# **ALACHUA COUNTY DEVELOPMENT REVIEW COMMITTEE STAFF REPORT**

**Project Number: DR25-000022**

**Final Development Plan and Flood Plain Development Permit for Dooley Dock**

**SUBJECT:** 778 square-foot dock and boathouse

Figure 404.108.1

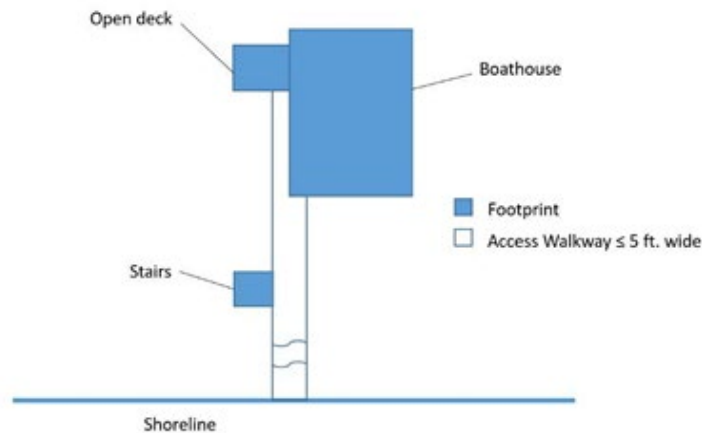
The proposed boathouse is 14 feet x 32 feet (12-feet x 30-feet with 1-foot roof overhangs) with a 11-foot x 30-foot open platform and 4-foot x 100-foot walkway. The completed dock terminal platform will be 778 square feet. The walkway is not counted in the total footprint.

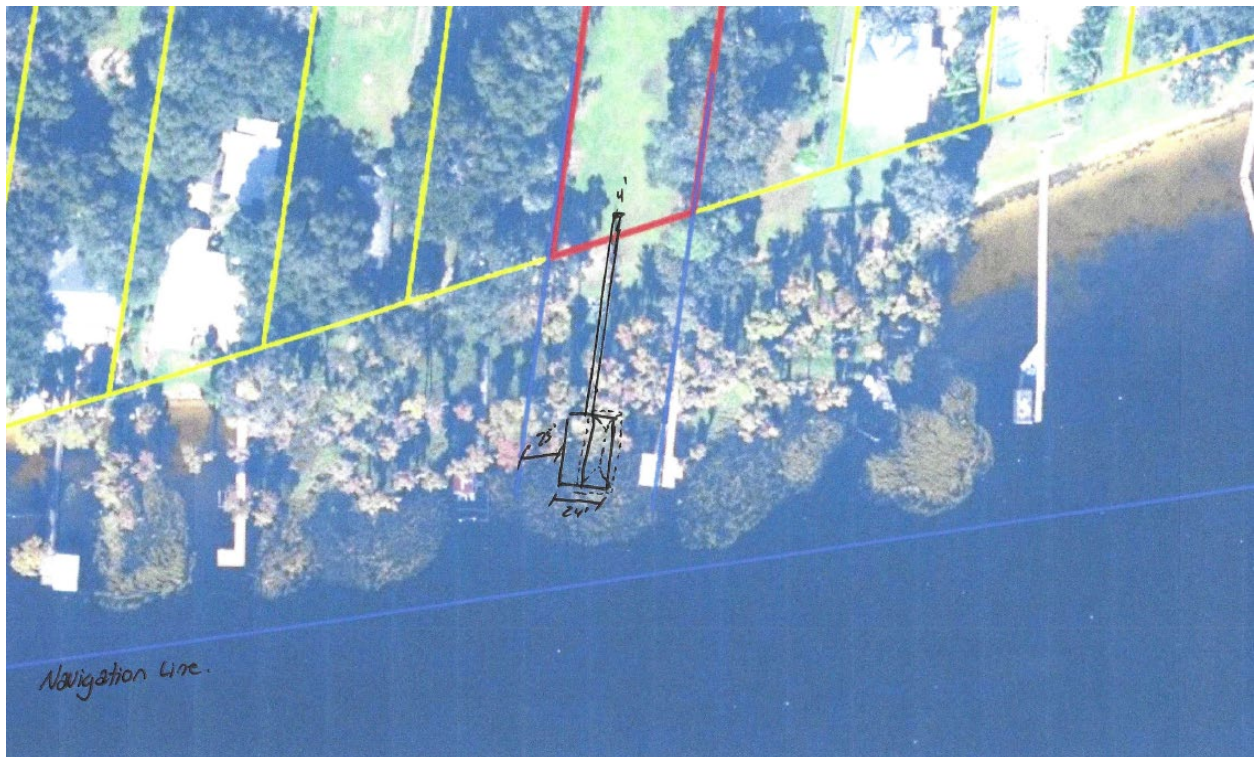
The covered width of the platform is 14 feet.
